Notice of Allowability

10/728,530

GANSER, MICHAEL

Fig. 2

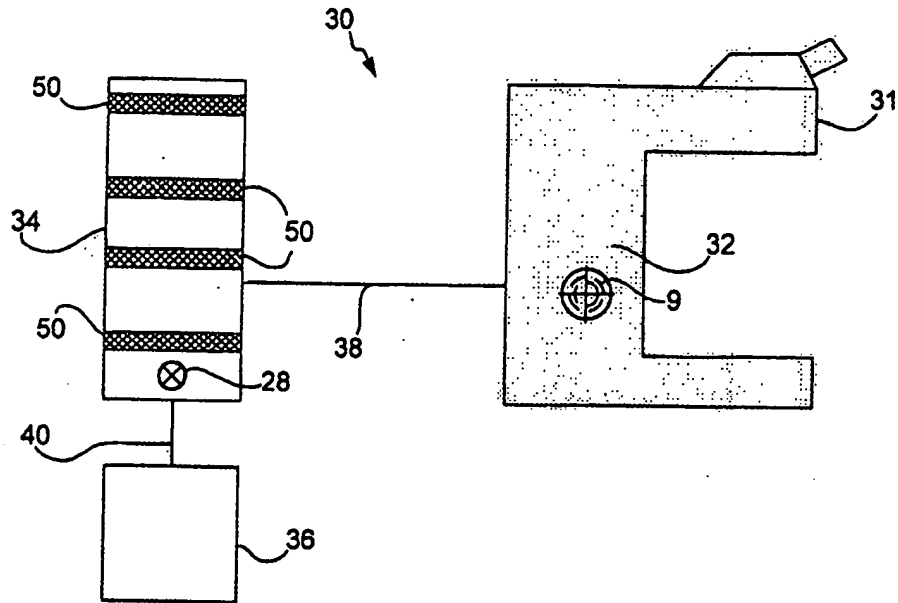
4. The drawings contained two corrected figures 2-3 was received on 7/5/2005. The corrected figures 2-3 are approved by the Examiner. As a result, the drawings of the present application now contain three sheets of figures 1-3.
